UNITED STATES PATENT AND TRADEMARK OFFICE

APPLICATION NO.	FILING DATE	FIRST NAMED INVENTOR	ATTORNEY DOCKET NO.	CONFIRMATION NO.
09/903,024	07/11/2001	James Morgan Murphy	SEA9783/30874.108USU1	9848
23552	7590	05/02/2006	EXAMINER	
MERCHANT & GOULD PC P.O. BOX 2903 MINNEAPOLIS, MN 55402-0903			MAGEE, CHRISTOPHER R	
			ART UNIT	PAPER NUMBER
			2627	
DATE MAILED: 05/02/2006

Office Action Summary	Application No. 09/903,024	Applicant(s) MURPHY, JAMES MORGAN	
	Examiner Christopher R. Magee	Art Unit 2627

DETAILED ACTION

**FIG. 4**

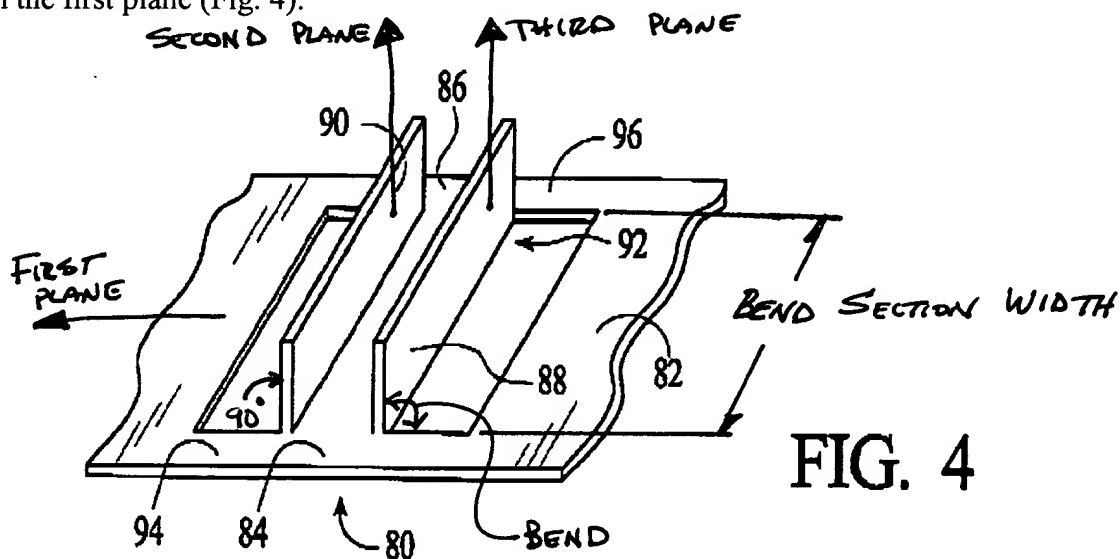
wherein a portion of the plate extending in the first plane connects the first and second rails together to form an open channel having a generally U-shaped cross section, and in combination a portion of the first and second rails extend across all of the bend section width (see annotated Figure 4).

Regarding claim 14, Berding shows the second and third planes are perpendicular to the first plane (Fig. 4).

Regarding claim 17, Berding shows the second and third planes extend at different angles from the first plane (Fig. 4).

"Although the flaps 88, 90 span much of the width of the hinge region 80, as shown in Figure 4, neither of the flaps individually or in combination extend across uncut regions 84, 86. Therefore, Berding fails to disclose 'in combination a portion of the first and second rails extend across substantially all of the bend section width' as required by claim 13."

Berding '715 shows "in combination a portion of the first and second rails extend across all of the bend section width" as indicated in the annotated Figure 4. Therefore, the Examiner maintains the rejection of claim 13.
